Response to reviewers comments for the AMT article “The pilatus unmanned aircraft system for lower atmospheric research” by de Boer et al. The original reviewers’ comments are in *italics*, and author responses are included in red text.

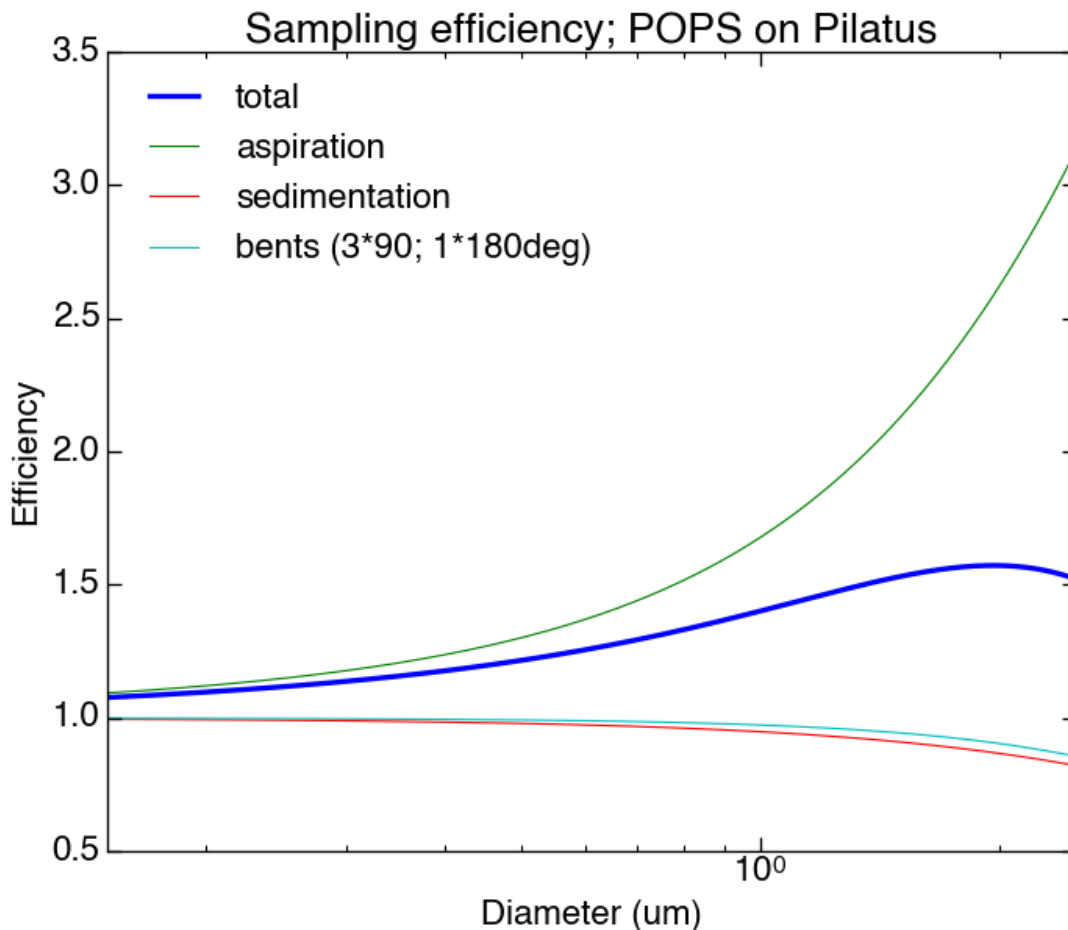
p. 11996 l. 7: How is the tubing constructed? What about the aerosol inlet system (isokinetic, isoaxial?) and sampling efficiency during cruising flight? (You can refer to (Baron and Willeke, 2001))

We use mainly stainless steel and some smaller section of conductive silicone tubing. The tubing has an inner diameter of 1/16 inch (0.0015875 mm), with an overall length of 65 inches (1.65 m). The inlet has the following bends (approximately): three at 90 degrees, and one at 180 degrees. We use an isoaxial configuration, but it is not isokinetic. As far as the sampling efficiency goes, the figure below shows estimates based on Baron and Willeke. This discussion and figure have been included in the manuscript.
